Rio Algom

**Subject: Re: Amendment 1 to Source Material License SUA-1548
Flare Factor Estimate Change and Justification
License No: SUA-1548 Docket No: 40-8964
Smith Ranch Facility**

In response to Amendment 1 to Source Material License SUA-1548, dated September 27, 2001, Rio Algom Mining Corp. is submitting changes to the license application dated November 15, 1999, as amended. These changes include amended language in Sections 6.2.7 and 6.2.8 as well as changes in Appendix 7 for Chapter 6 of Volume I of the License Application. These changes reflect the methodology used by RAMC to estimate the flare factor of its wellfields for the development of the reclamation bond amount. As justification for the flare factor estimate methodology, RAMC has also attached the groundwater modeling report performed by a groundwater consultant. This report will be amended to the license application as Appendix K in Volume V.

**Methodology for Flare Factor Determination**

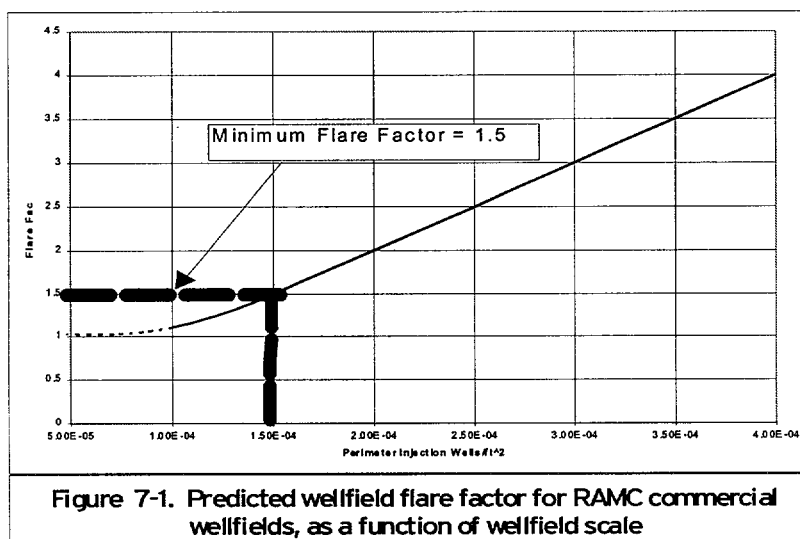
Figure 7-1 is derived from Figure 3-16 in *"Evaluation and Simulation of Wellfield Restoration at the RAMC Smith Ranch Facility"* dated October 29, 1999 (provided as Appendix K of this application). This document was submitted to the Wyoming DEQ - Land Quality Division with a letter dated December 13, 1999 for review. In that document, RAMC proposes a methodology developed through hydraulic and geochemical modeling that uses the geometry of the wellfield to estimate a Flare Factor. In this case, the number of perimeter injection wells are counted, the surface area of the wellfield pattern is measured using a wellfield map, a ratio is developed of the # of perimeter injection wells to the surface area of the wellfield patterns. That ratio is located on the horizontal axis of figure 7-1 (above). From that intercept, a vertical line is projected to intersect the curve. At that intersection, a horizontal line is projected to intercept the vertical axis. The estimated flare factor is derived from that intercept.

approach for estimating groundwater restoration costs. RAMC verified that the curve shown on Figure 7-1 had been validated using modeling for flare factors of 1.5 and higher, but it had not been verified for Flare Factors lower than 1.5. RAMC stated that for bonding purposes only, it would not use a Flare Factor lower than 1.5 for estimating the predicted costs for groundwater restoration.

Figure 3-16. Predicted wellfield flare factor for RAMC commercial wellfields, as a function of wellfield scale

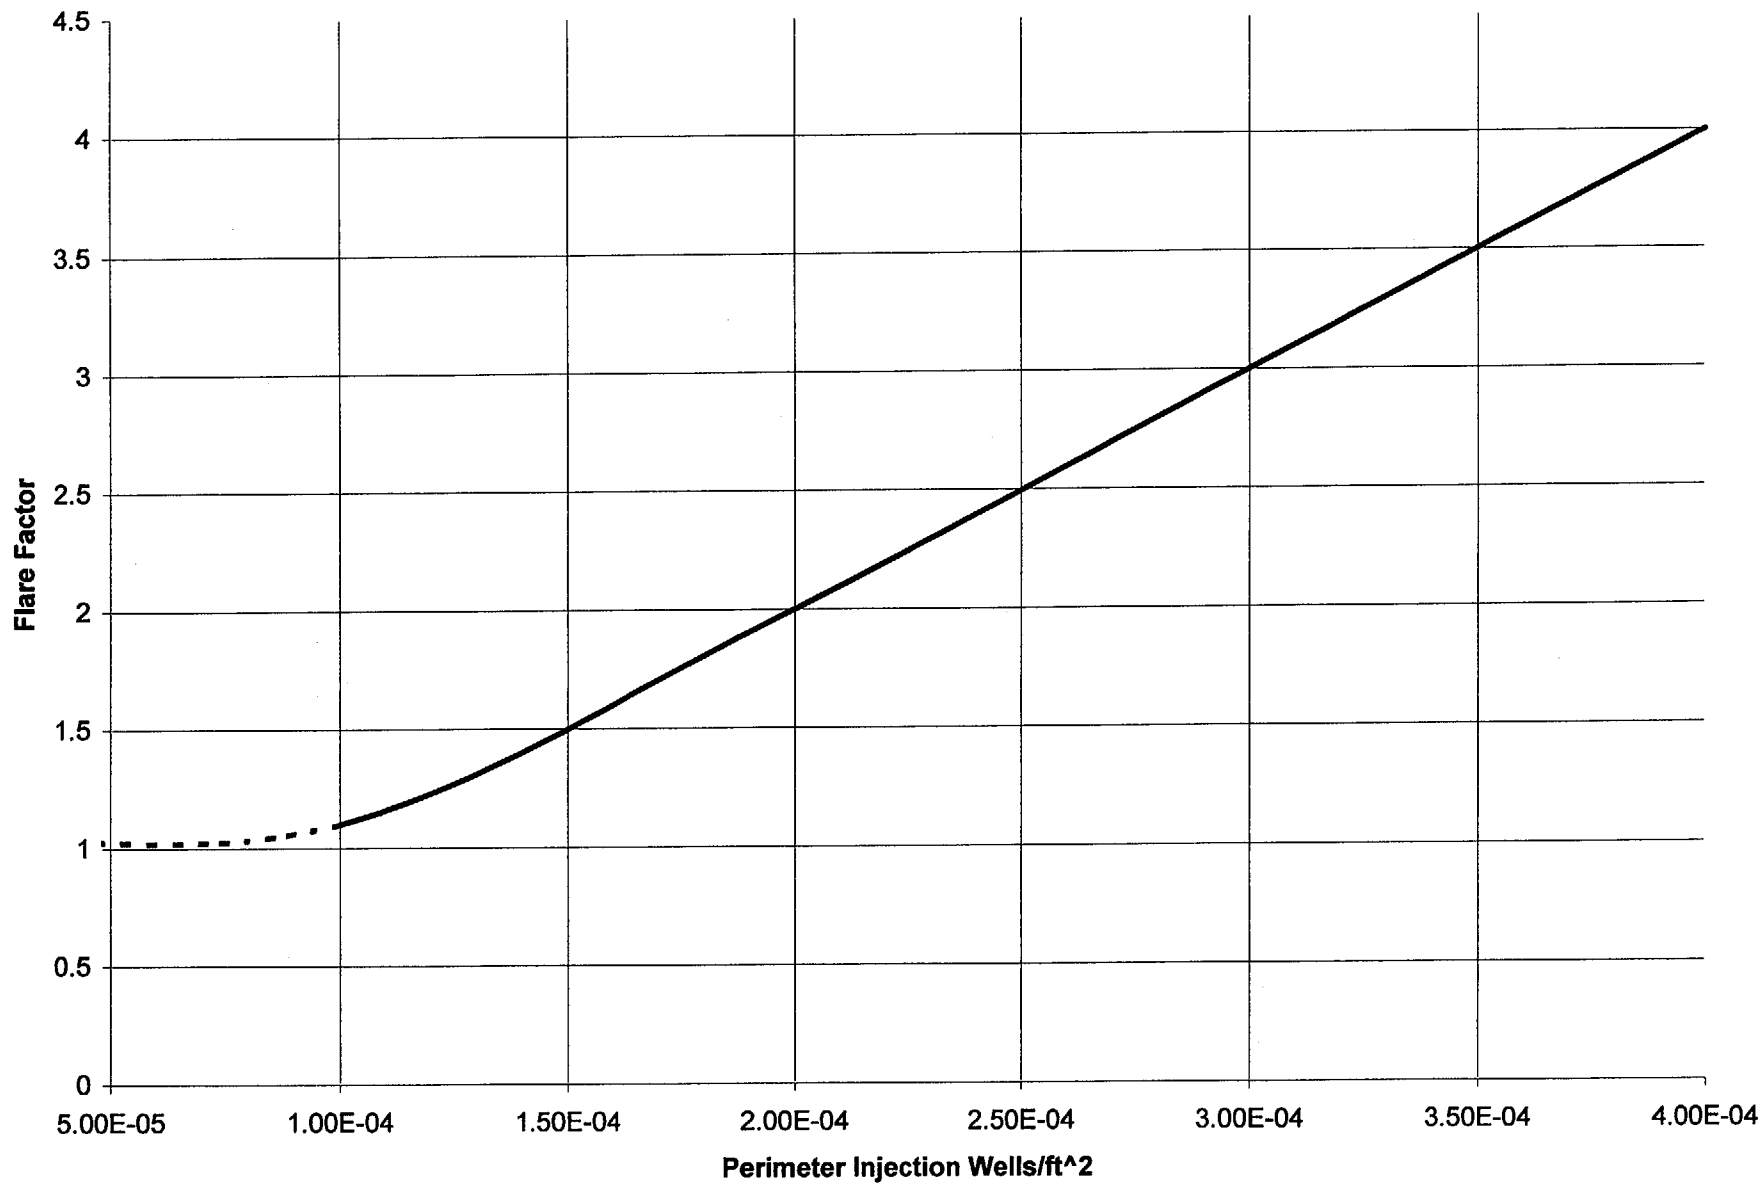
Figure 3-16 provides the predicted flare factor versus wellfield scale (number of perimeter injection wells/ft²) constructed from results of the sensitivity analyses. Figure 3-16 assumes a net production rate of 0.08 gpm/well and a Kh/Kv ratio of 100:1 (e.g. no vertical flare). These results can be used to estimate appropriate flare factors for remaining commercial wellfields (other than Wellfield 1) at the Smith Ranch facility.

Figure 3-16 assumes that the wellfield flare factor cannot be less than 1.0 (although flare factors less than 1.0 can be shown to exist). Therefore, as a conservative measure, the linear relationship between flare factor and wellfield scale was assumed to be strictly valid only for perimeter injection well densities less than about $1.5\text{e-}04$ wells/ft². It is assumed that the flare factor approaches 1.0 asymptotically at very low injection well densities.
